DOUGLAS AND LAWSON CREEK
 BRIDGES STRUCTURAL REPAIRS
 STP-0958(9) 71123
ESTIMATE OF QUANTITIES

LAWSON CREEK BRIDGE
Route No. F-095
PIN AND HANGER REPAIRS
(No Scale)

DOUGLAS BRIDGE
ROUTE NO. FAU 958
REPAIR / REHABILITATION

EXISTING PIN & HANGER ASSEMBLY

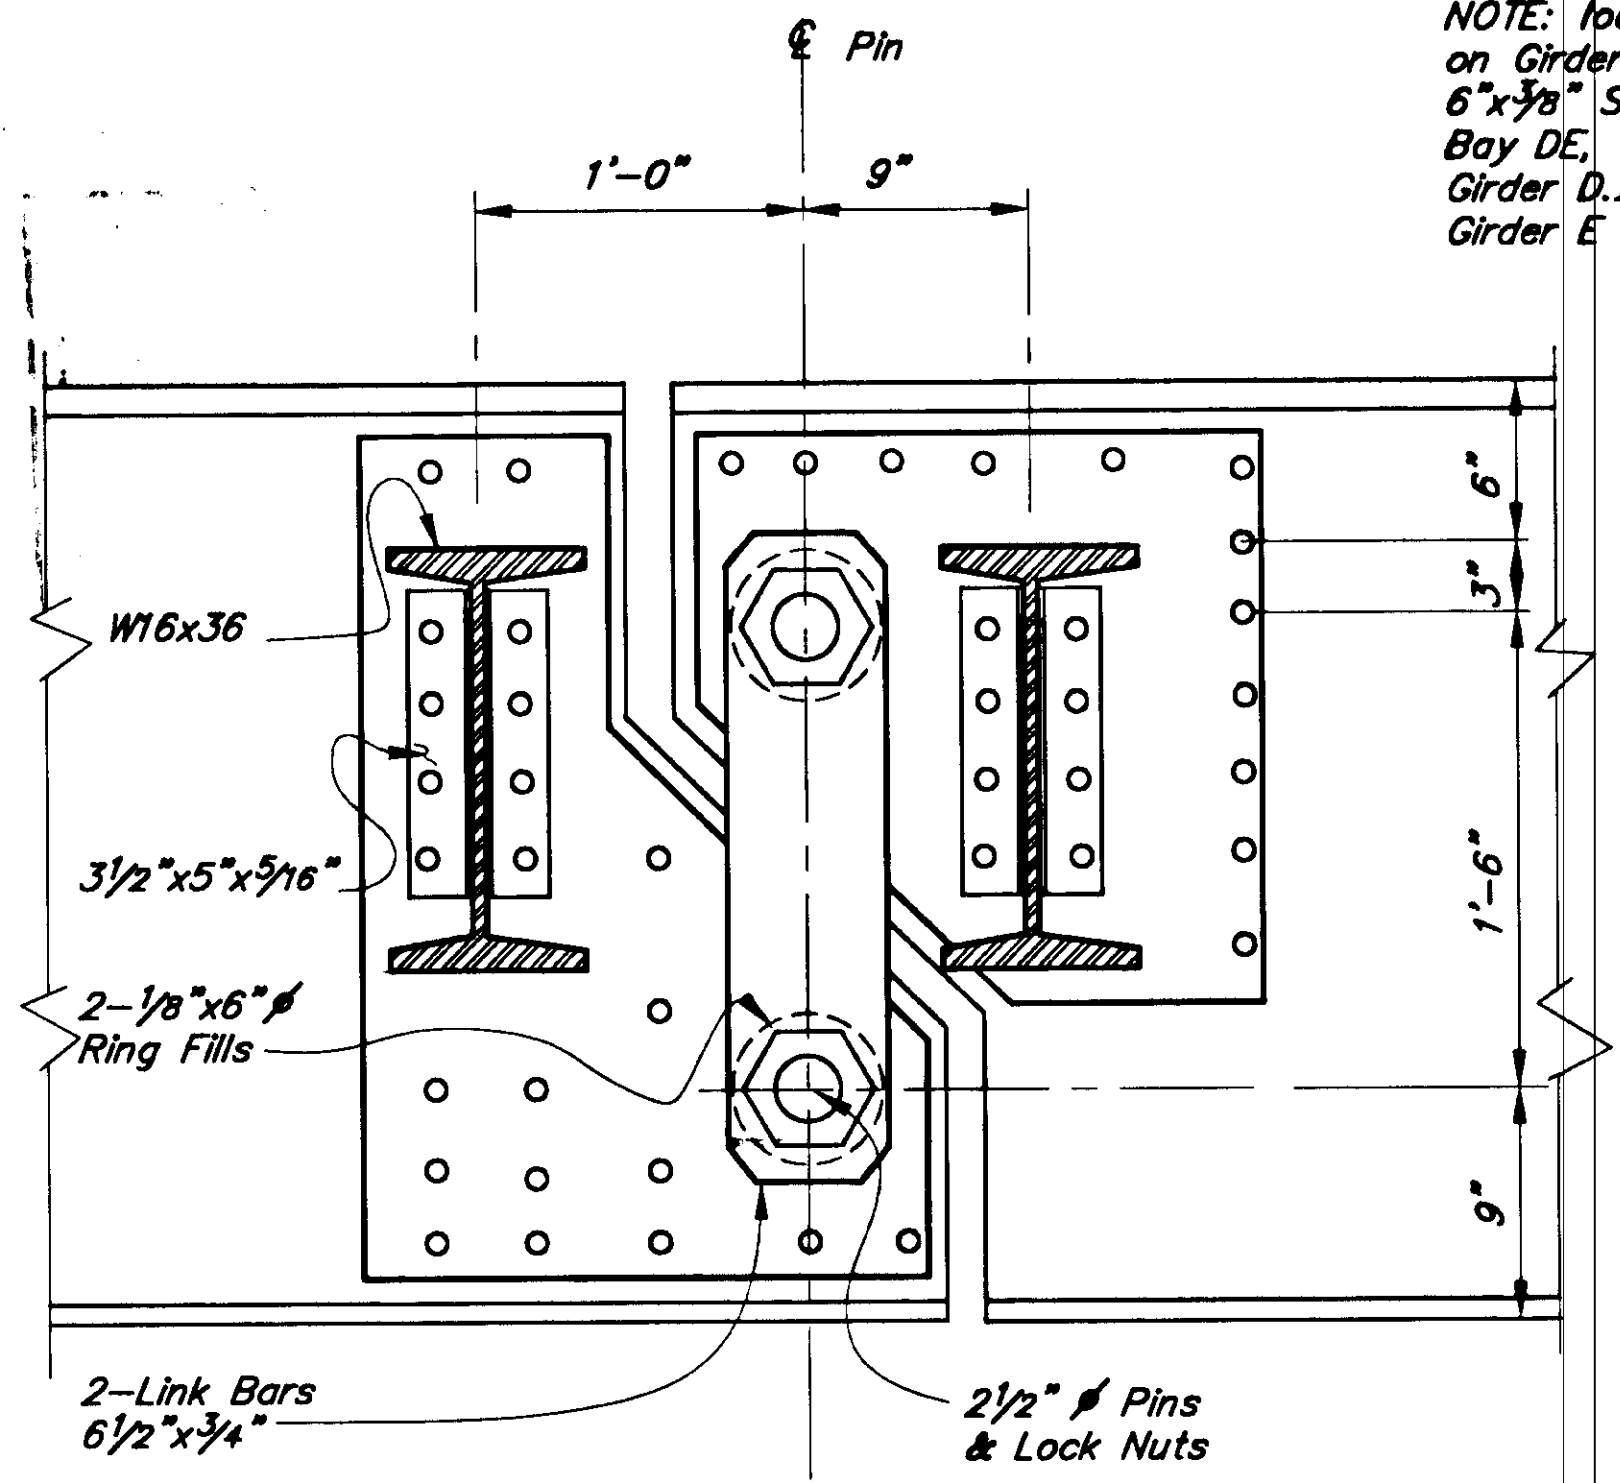
NOTE: location of W16 diaphragm on Girder D. Modify location of 6"x3/8" Stiff. Plate, Girder E Bay DE, to meet diaphragm from Girder D. Increase size of plate on Girder E accordingly.

EXISTING PART SECTION ON E PINS

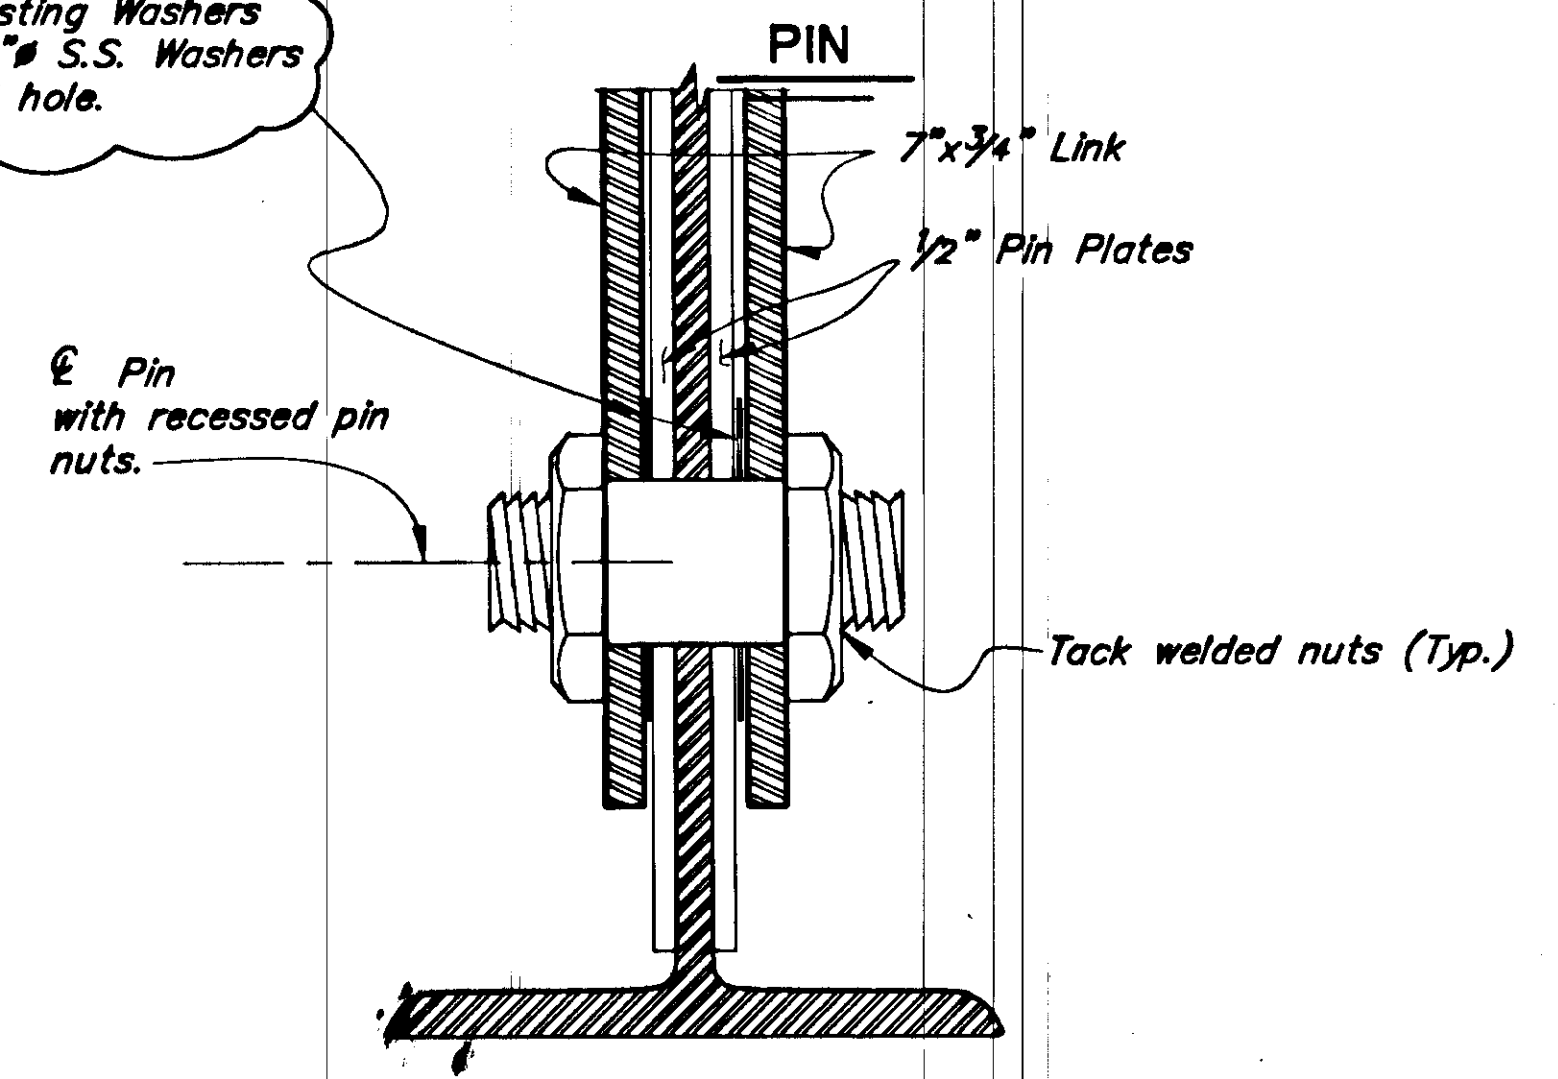
For This Contract: replace existing Washers with 1/8"x6" S.S. Washers with 3/8" hole.

SPACER PAD STA. 21+70
(2 Req'd)
NO SCALE

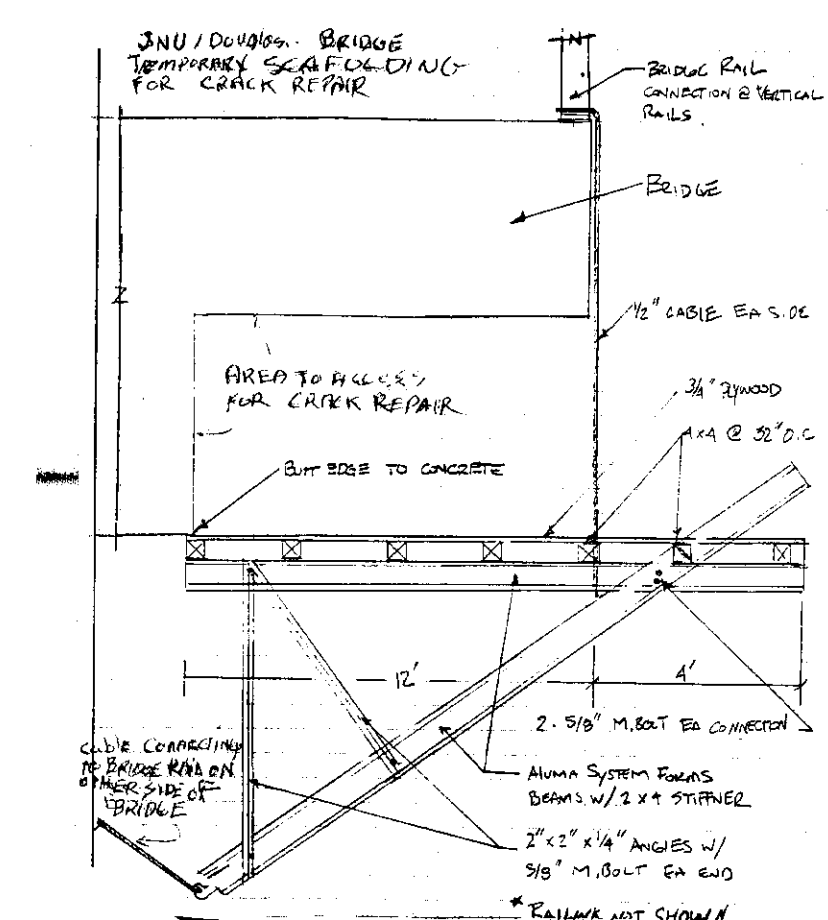
For this Contract: Insert $\frac{1}{8}$ " x 2'-1" x 3'-1" Stainless Steel Between TFE Coatings

**PLAN VIEW NEW EXPANSION DEVICE
ABUTMENTS**

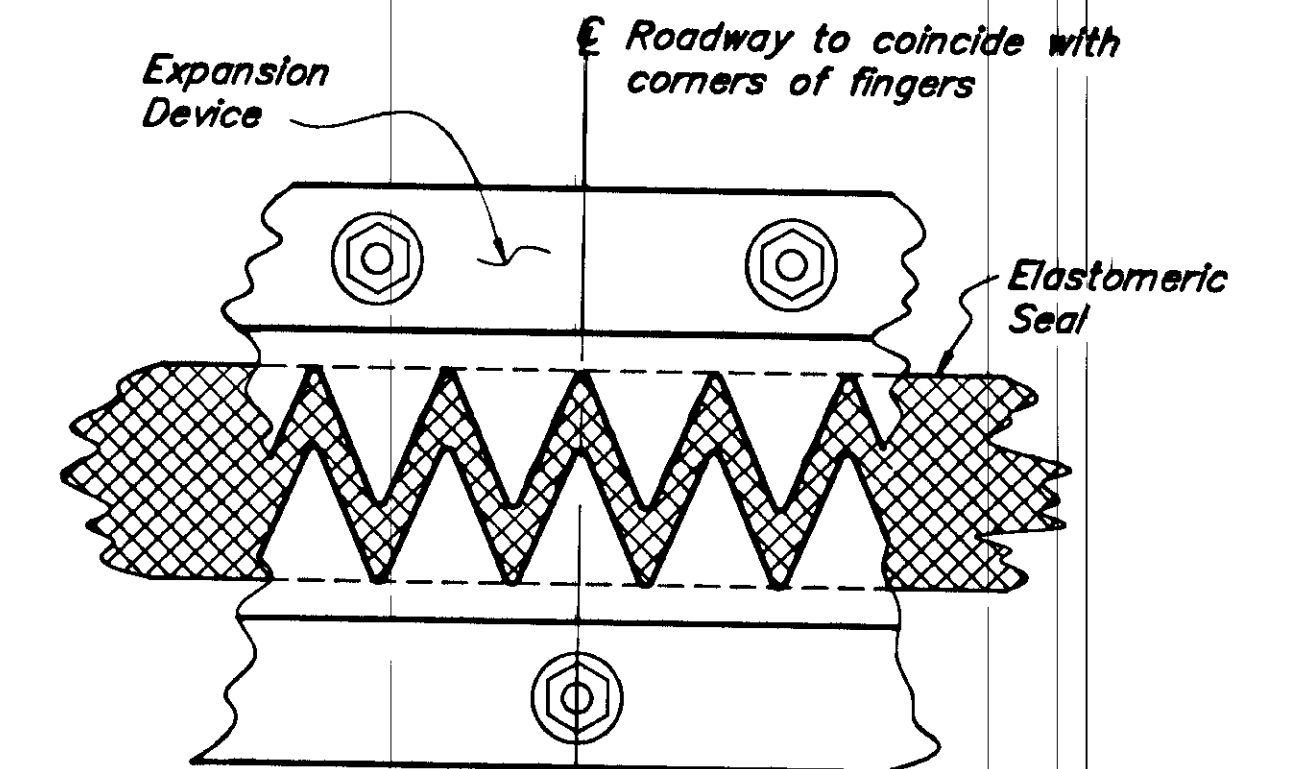
* Repair 10"x14"x30" spalled concrete (Douglas end) as needed to As-Built condition

** Expansion Gap per field measurement @ 69F:
Juneau End = 3 1/2"
Douglas End = 1 3/4"
